SUBJECT: Addendum No. 2- RFI No. 1, 2, and 3
City of Cartersville, GA
Pinson Dr., Cut-Off Rd., and Patterson Drive Water Main Replacement

ADDENDUM NO. 2

Project Name: Pinson Dr., Cut Off Rd., Patterson Dr. Water Main Replacement

Construction RFI Response

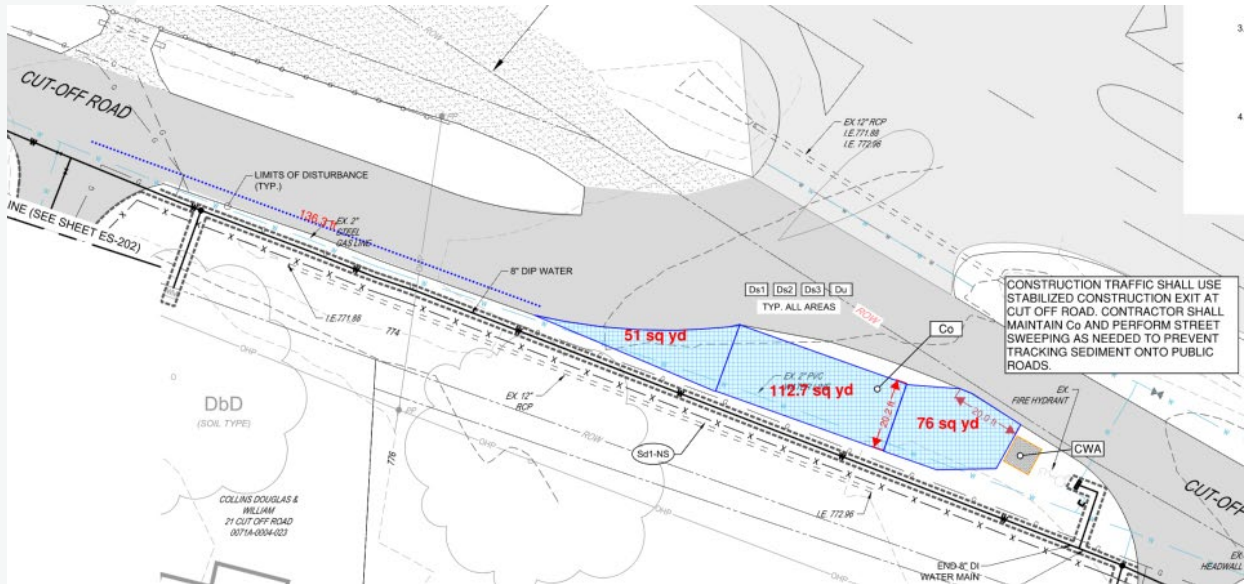
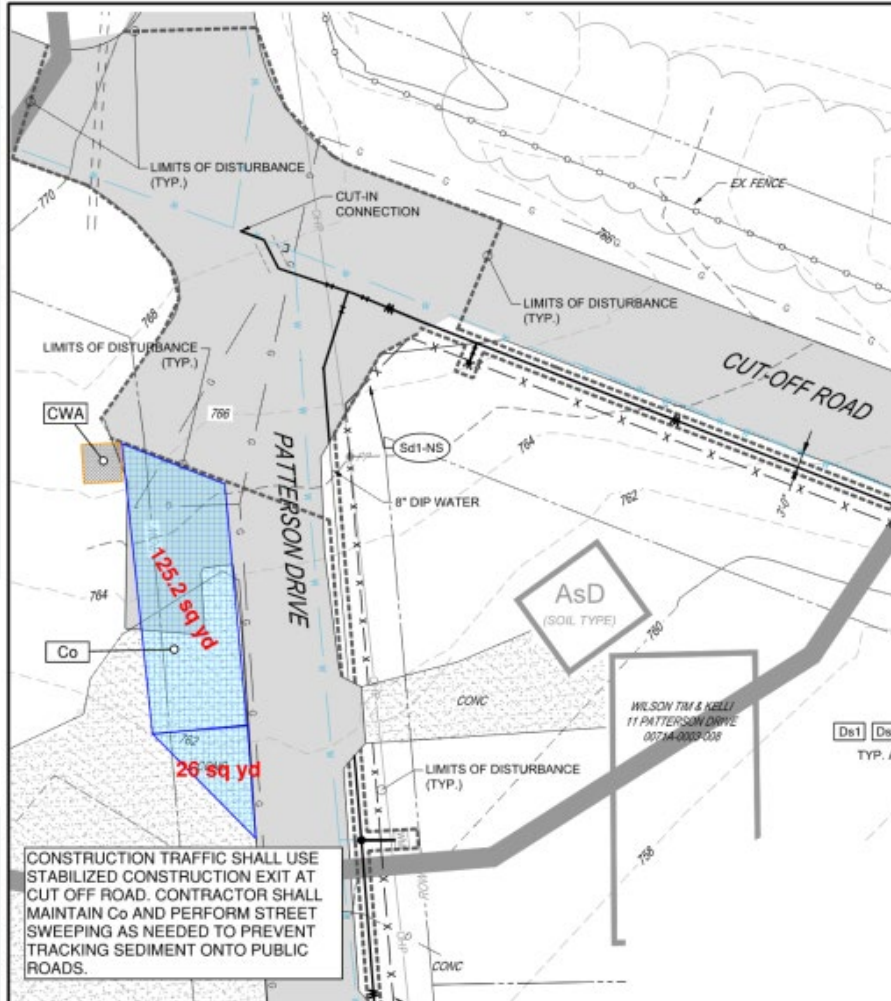
- b. How will this excavation line item be measured and paid?
4. Line Item 31 – Sedimentation and Erosion Control
 - a. Please identify the locations of the construction entrance (CO) and concrete washout (CW) on the plans.

- b. The plans show Ch-Rp symbols, but there is no corresponding pay item. Should this be included as a separate line item?
5. Line Item 32 – New and Replacement Paving

- Two possible locations for the Co and CWA are shown below:

The callouts for Ch-Rp are incorrect. Filter rings, Fr, are intended for these locations at the ends of culverts and are included in the Bid Schedule.

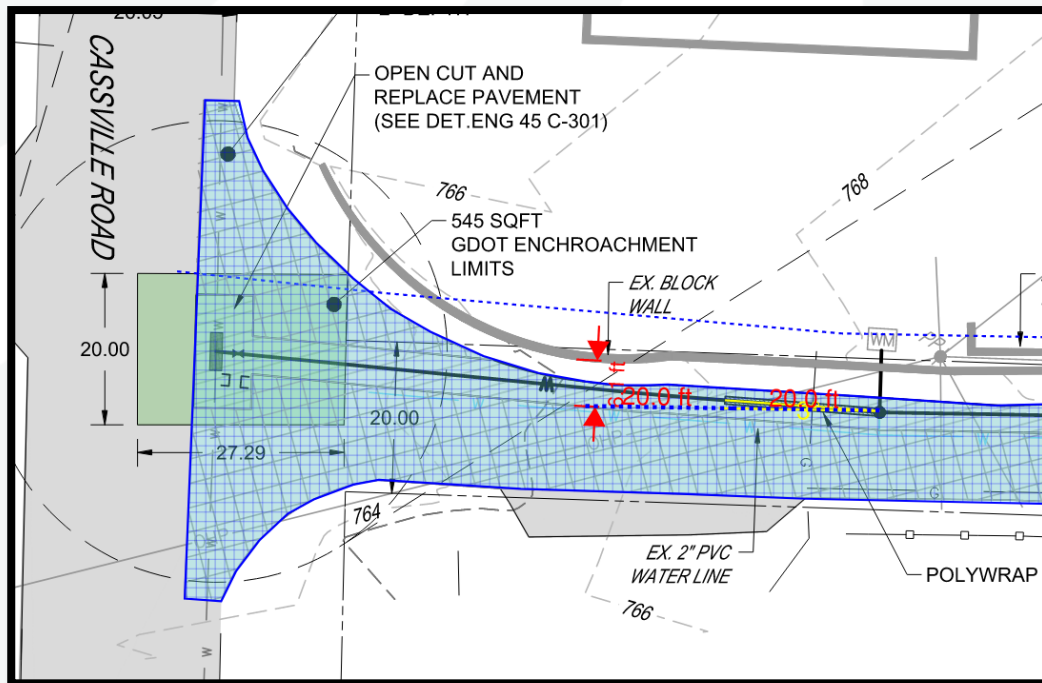
1. There are a few service line connections coming off the proposed 2" PVC line. Will pay items be added for 2 IN x 3/4 IN tapping saddles?
2. On C-201, an existing block wall is shown. After visiting the site, the trench is not in conflict, but the equipment needed to dig the trench will be. We believe the trench would need to move or the block wall would need to be removed and replaced. How will this be addressed?
3. Do we have to bore under driveways or can contractor open cut and replace driveways at the contractor's expense?

1. Yes. Four 2 IN x 3/4" Tapping saddles will be added to the Bid Schedule by addendum.
**** An addendum will be issued to account for these changes in Bid Schedule quantities. ****
2. One possibility is to deflect the pipe 3' far enough in advance of the wall to get the necessary clearance, go beneath the existing 2" WM, and deflect back to tie-in point. Forty feet prior to the narrowest clearance point at the wall will provide 6-feet of clearance. See figure below:
